Consumer Product Service Menager of Tehnical Support JPGRADE BULLETIN

DATE: May 23, 1982

310 Disk Drive, ROM, Revision C,

Silkscreen 310 Side Board

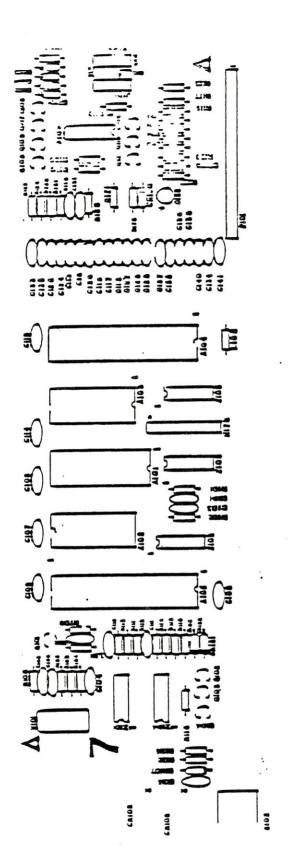
Remove CO11299B from Location A102 on sideboard, and insert CO11299C.

Part Location - Sideboard, CAO14834 Location A102
